# **Planning Proposal**

## **1 - 5 Chester Street, Annandale**

### **URBAN DESIGN REPORT**

Peer Urban Design Review

## **Urban design amendments proposed by Council**

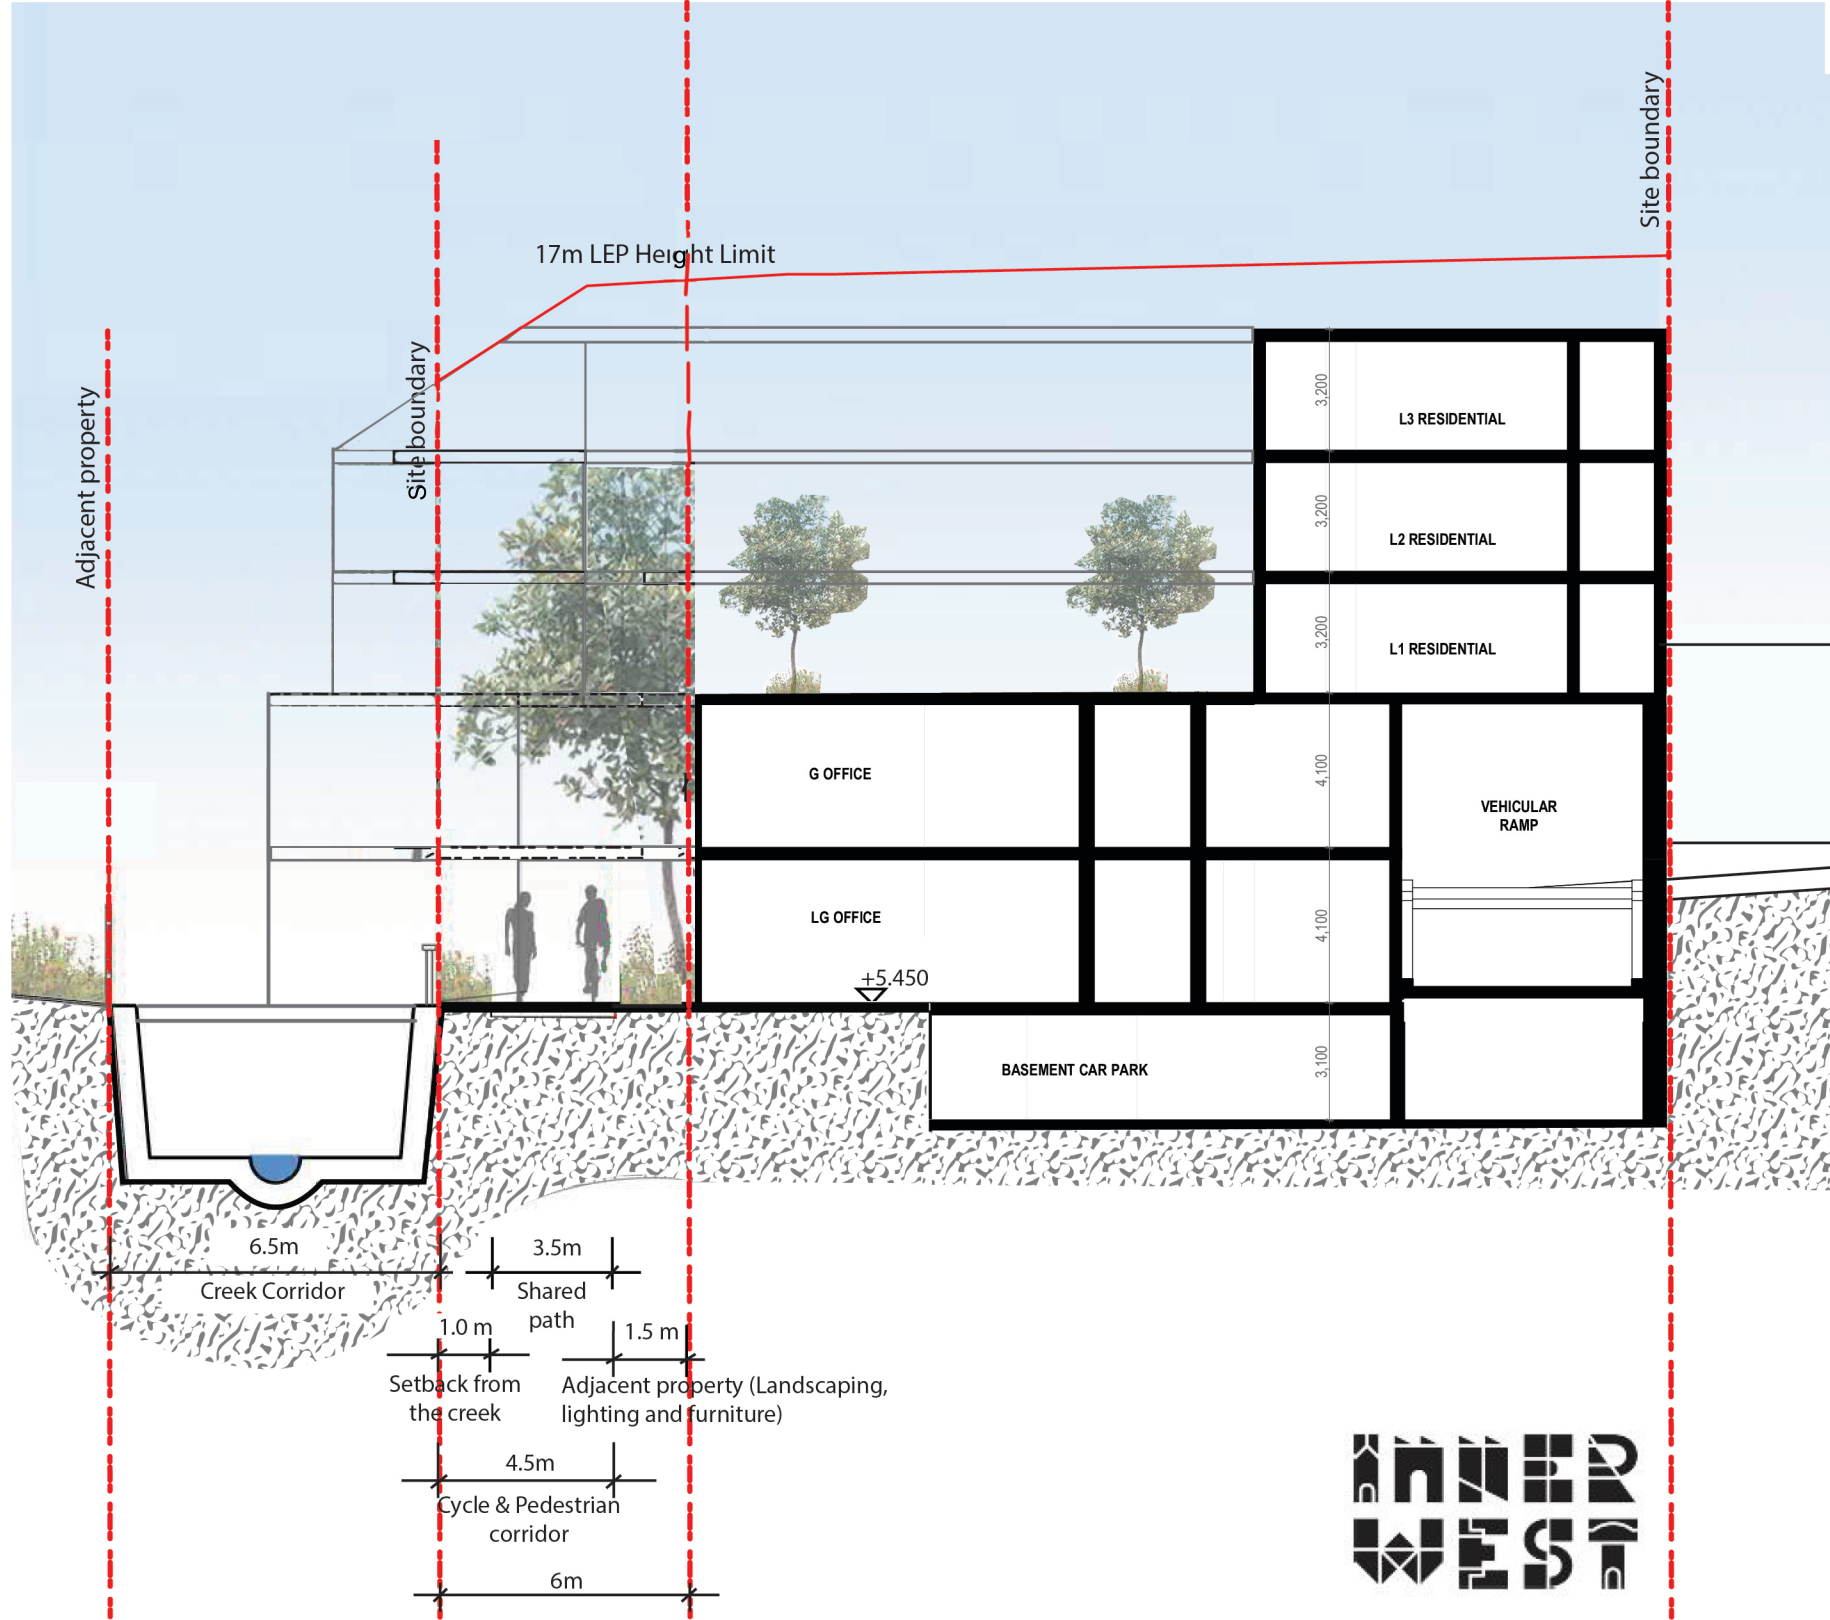
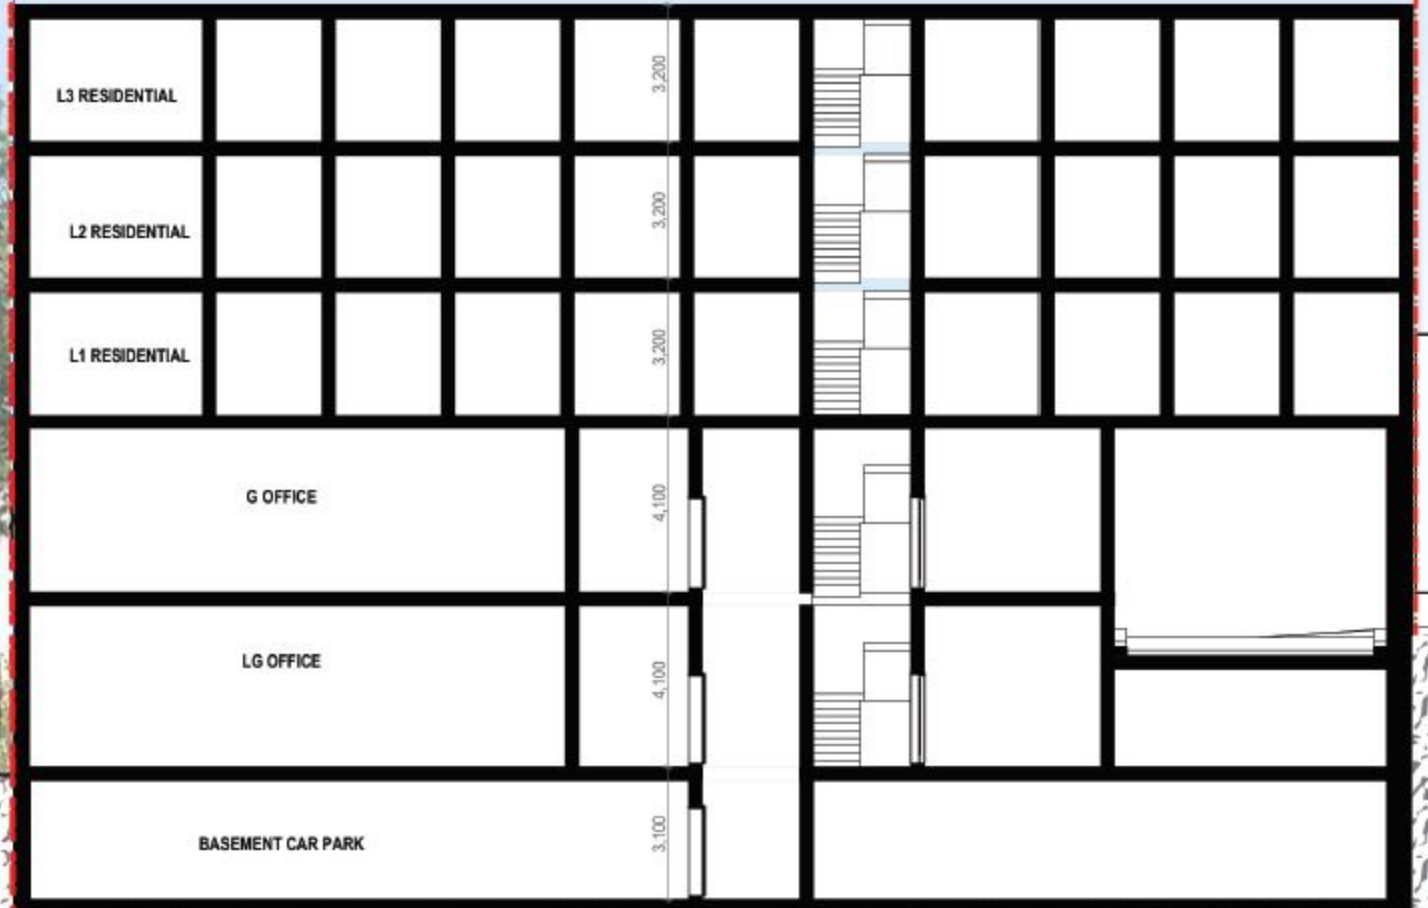
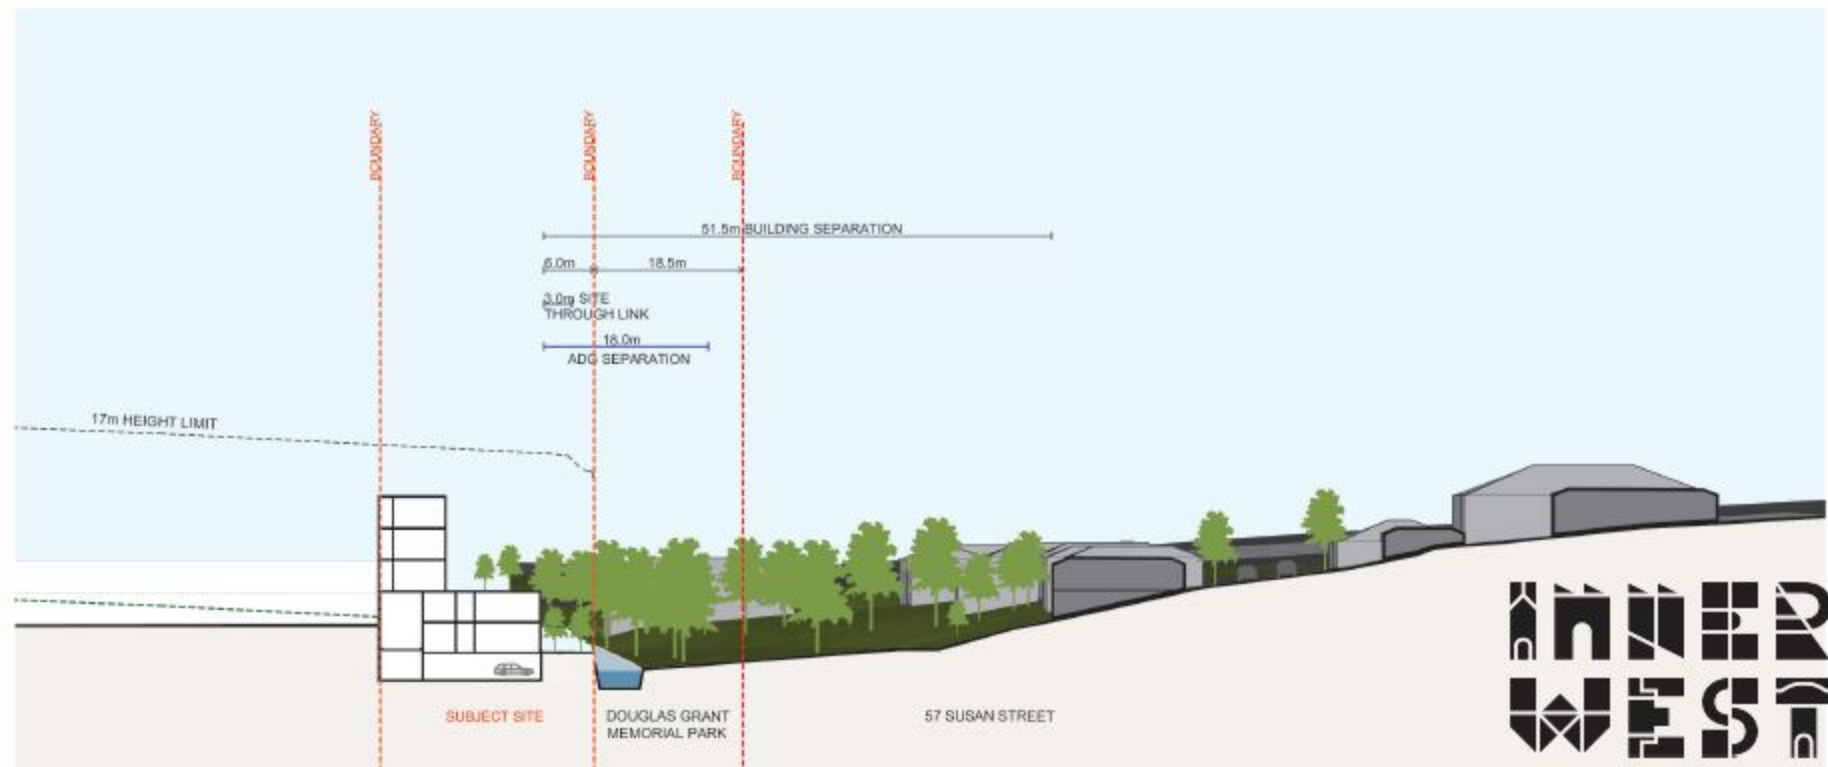
1. Proposed site plan with the correct location of the through site-link
2. Proposed north-south section through the creek and podium (with 6m setback to the basement)
3. Proposed north-south section through the creek and student housing (with 6m setback to the basement)
4. Proposed cross-sections through the site, creek and surrounding sites (with 6m setback to the basement)

Ground plan showing industrial units with out street frontage  
(Extracts from Urban Design Report May 2019 by ae design partnership)

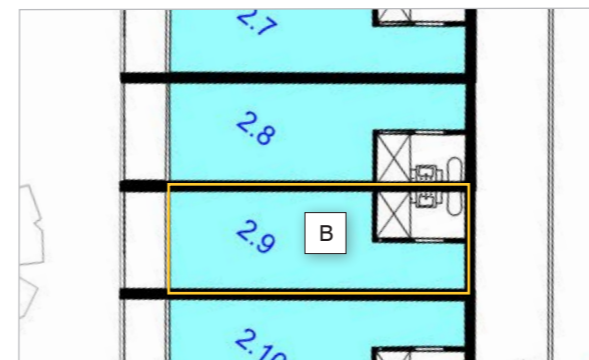
Issue	Appropriateness of May 2019 proposal	Justification	Preliminary recommendation
Land use	<p><u>Urban Design</u></p> <ul style="list-style-type: none"> <li>The proposed typology for a mixed use building is atypical and not considered appropriate.</li> <li>The proposed industrial uses which are individual 'creative offices' have limited street frontage and appear more as home offices. There is also no large vehicle access to service these uses [A]</li> <li>Compatibility of residential uses and industrial uses in this form may cause land use conflicts (as described further under Bulk and form).</li> <li>The boarding house unit sizes (approx min 18sqm) are similar to what is being delivered across Sydney. The amount of communal space is acceptable however no communal open space is not (further discussed in Open Space and Deep soil).</li> </ul> <p><u>Planning</u></p> <ul style="list-style-type: none"> <li>The proposed typology for industrial uses would not deliver on the state government and Council's vision for the Camperdown precinct or the objectives for the IN2 Light Industrial zone in LLEP2013.</li> <li>The proposed boarding house uses align with the PRCUTS recommended land use for the site however not with the proposed timeline.</li> </ul>	<p><u>Urban Design</u></p> <ul style="list-style-type: none"> <li>Floorplates should be as flexible as possible to ensure buildings can respond to changes to market demand over time.</li> <li>Businesses generally require a street frontage and front door.</li> <li>Industrial floorspace and its ability to function should be protected.</li> <li>15-20% of student housing FSR is typically for common areas</li> <li>SEPP (Affordable and Rental Housing) requires minimum 12sqm for single occupant boarding house. Example of boarding house unit in Sydney is shown below and compared to the proposal [B]</li> </ul> <p><u>Planning</u></p> <ul style="list-style-type: none"> <li>The Parramatta Road Corridor Urban Transformation Strategy (PRCUTS) in conjunction with the Greater Sydney Regional Plan and the Eastern Harbour City District Plan underline the importance of the Camperdown Precinct as part of the Camperdown Ultimo Collaboration area with a focus on the biotechnology sector.</li> <li>While the PRCUTS recommends that the site be zoned R3 Medium Density Residential (with a focus on key workers, affordable housing and student housing), the site is not proposed for residential development until after 2023, as it is outside the boundary of the PRCUTS Implementation Plan for 2016-2023.</li> <li>The proposed typology would be unlikely to meet the objectives of the IN2 Light Industrial zone in the LLEP2013, such as 'to support and protect industrial land for industrial uses'.</li> </ul>	<ul style="list-style-type: none"> <li>Architectus is not opposed to a mix of uses on the site (including residential uses) provided that the site can: <ul style="list-style-type: none"> <li>deliver the employment uses envisioned for the Camperdown Precinct</li> <li>ensure residential uses are well separated to prevent compatibility issues that would detract from the future employment potential of the precinct.</li> </ul> </li> <li>Architectus is however concerned with the proposed mixed use typology which is atypical. The model should be checked, as from Architectus' experience: <ul style="list-style-type: none"> <li>Industrial uses prefer to have flexible large floorplates and street frontage. A large industrial floorplate also allows residential uses to be well separated.</li> </ul> </li> <li>Council should know that a final design could vary considerably and be satisfied appropriate controls will ensure a high quality boarding house outcome.</li> <li>Council should seek to be satisfied that the uses proposed are the right typology which can be delivered on the site, achieve the vision for the Camperdown Precinct and provide flexibility to meet future needs.</li> </ul>

Plan of section cut location showing continuous 6 storey perimeter building and 0m separation at south of site to adjacent site (15 Chester Street) (Extracts from Urban Design Report May 2019 by ae design partnership)

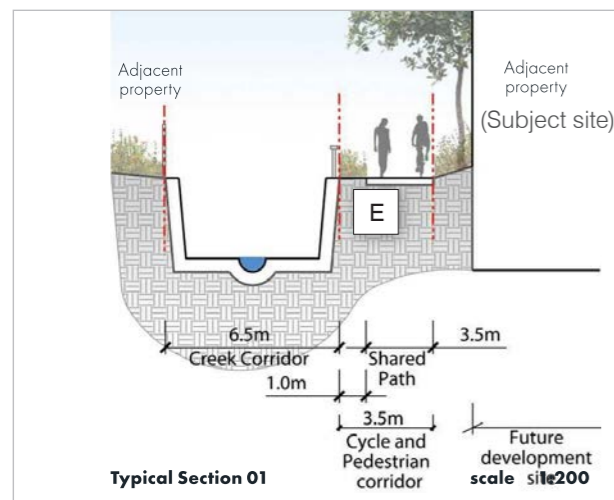
Issue	Appropriateness of May 2019 proposal	Justification	Preliminary recommendation
Bulk form and scale	<ul style="list-style-type: none"> <li>The continuous perimeter building is not appropriate for the sites context, as it provides a poor interface with its neighbours with regard to overlooking, scale transition, building and land use separation.</li> </ul>	<ul style="list-style-type: none"> <li>Interface to Johnstons creek frontage: Dwellings to the west are of a low scale with back gardens facing the site:               <ul style="list-style-type: none"> <li>The 6 storey street wall does not provide a good scale transition to its neighbours.</li> <li>The 4 levels of residences oriented to this frontage will directly overlook the neighbours from a short distance which will result in poor amenity impacts. Oblique views may also be blocked.</li> <li>Note: The renders do not show the preferred option - appear to show Option 2 from the May 2019 Urban Design Report, which includes some height variation (5 and 6 storeys) along Johnstons Creek frontage [C].</li> </ul> </li> <li>Interface to Chester Street frontage: The PRCUTS highlights the importance of relating building height to street width and intended character.               <ul style="list-style-type: none"> <li>A 5 storey street wall on Chester Street is not achievable under the height limit of 17m</li> <li>The street wall on Chester Street provides minimal separation (11m) to the opposite site (1-19 Booth Street). The opposite site has an existing DA (D/2019/125) under assessment for a 6 storey mixed use building built to boundary on Chester Street. The interface of residential uses (on site) fronting Chester Street and industrial/commercial uses (on adjacent site) needs to be carefully managed to prevent land use compatibility conflicts.</li> </ul> </li> <li>Interface to adjoining site to south east: Development on the site must carefully considers its relationship with the adjacent site at 17 Chester Street to prevent land use conflicts between industrial and residential uses and allow the adjacent lot to also redevelop in the future.               <ul style="list-style-type: none"> <li>The separation and orientation of the building to the adjacent site is not appropriate. While the boarding house units front Chester Street and Johnstons Creek, the south east facing corridor overlooks the adjacent lot at a short distance which has the potential to cause conflicts with the neighbouring industrial uses, such as noise from trucks. The overlooking may also inhibit the future redevelopment of that site.</li> </ul> </li> </ul>	<ul style="list-style-type: none"> <li>The proposed bulk, form and scale of the development is too large for the sites context. The continuous perimeter building interfaces poorly with its neighbours.</li> <li>The built form should be revised to be less bulky and intrusive on neighbours. This could be done by setting back the residential component from Chester Street and breaking down the street wall on Johnstons Creek frontage and reorientating the building to optimise visual and acoustic privacy to the Johnstons Creek frontage and the adjacent industrial lot at 17 Chester Street.</li> <li>An indicative design of 17 Chester Street should be developed to ensure both sites can redevelop in a cohesive way.</li> </ul>

The built form should be revised to be less bulky and intrusive on neighbours. This could be done by setting back the residential component from Chester Street and breaking down the street wall on Johnstons Creek frontage and reorientating the building to optimise visual and acoustic privacy to the Johnstons Creek frontage and the adjacent industrial lot at 17 Chester Street. An indicative design of 17 Chester Street should be developed to ensure both sites can redevelop in a cohesive way.

Section of proposal showing difference in terrain level either side of the creek (Extract from Urban Design Report May 2019 by ae design partnership)

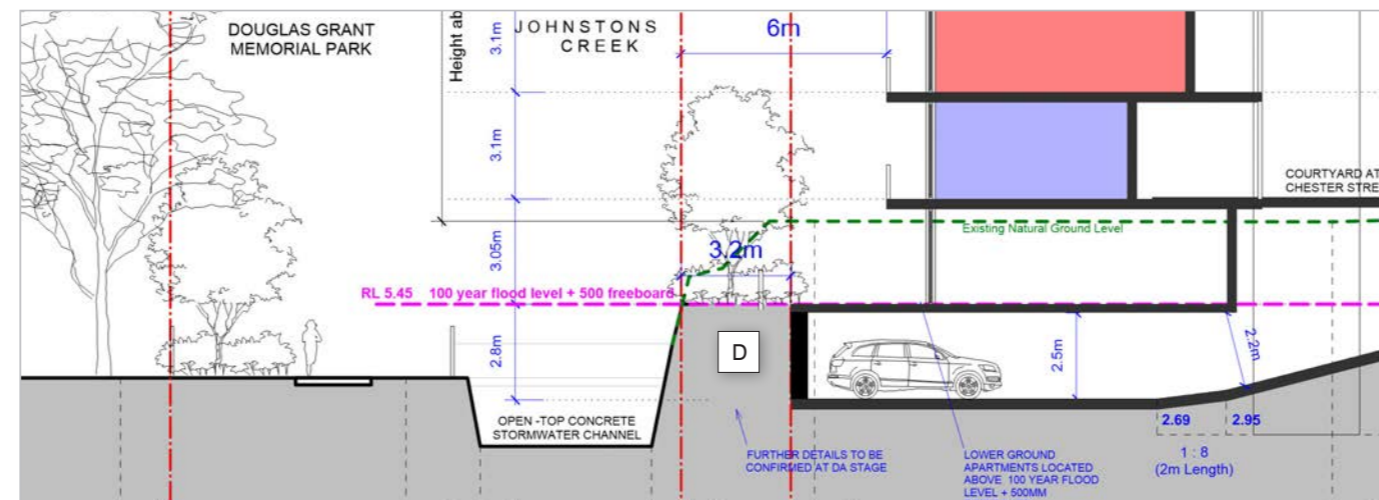
Slope and levels	<ul style="list-style-type: none"> <li>The terrain level on the Johnstons Creek frontage is lifted up to RL 5.45 to be above the 100 year flood level (according to the section), which is approx 2m higher than the terrain level on the opposite side of the creek [D]. This is not appropriate as it results in a poor interface with the creek and the properties west of the creek including Douglas Grant Park.</li> </ul>	<ul style="list-style-type: none"> <li>Developments should optimise the interface with the natural environment. By lifting the terrain, the difference in topography either side of the creek is exacerbated. The site feels disconnected from the creek frontage and its neighbours.</li> <li>Douglas Grant Park is a key local public space and it is important that adjacent properties contribute to providing an attractive frontage to this space with good passive surveillance.</li> <li>Council's proposed shared path shows the same terrain level either side of the creek [E]</li> <li>Note: There is an inconsistency in ground heights between the section shown and the render. The render appears lower as the basement carpark is visible [F].</li> </ul>	<ul style="list-style-type: none"> <li>The terrain on the Johnstons Creek frontage should be lowered to match the terrain height of the properties and park west of the creek, as per Council's Section of the proposed share path and thus provide a better interface with the creek. Note the basement level of the development needs to be appropriately screened so it doesn't provide a blank wall to this frontage.</li> </ul>

The terrain on the Johnstons Creek frontage should be lowered to match the terrain height of the properties and park west of the creek, as per Council's Section of the proposed share path and thus provide a better interface with the creek. Note the basement level of the development needs to be appropriately screened so it doesn't provide a blank wall to this frontage.

Basement plan highlighting tight turn at the bottom of the ramp

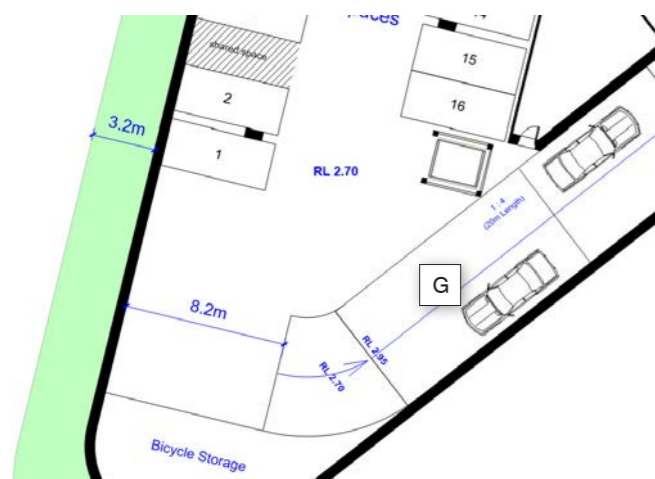
Movement and access	<p><u>Pedestrian</u></p> <ul style="list-style-type: none"> <li>The proposed 'creative office' units should be accessed from the Chester Street frontage as this is the primary frontage for the development.</li> </ul> <p><u>Vehicular</u></p> <ul style="list-style-type: none"> <li>The turn at the bottom of the carpark ramp seems very tight and if the carpark is to be setback 6m from the Johnstons Creek frontage that will most likely not work. [G] It is noted, it may be acceptable for the basement to step out into the setback below basement level.</li> <li>The proposal does not provide include truck access.</li> </ul>	<ul style="list-style-type: none"> <li>Industrial uses prefer street frontage and front door.</li> <li>Industrial uses require truck access to site.</li> </ul>	<ul style="list-style-type: none"> <li>The industrial units typology should be reviewed (as described under Land Use) and ensure the industrial uses have a primary frontage and can be accessed from Chester Street.</li> <li>Configuration of carpark should be revised.</li> </ul>
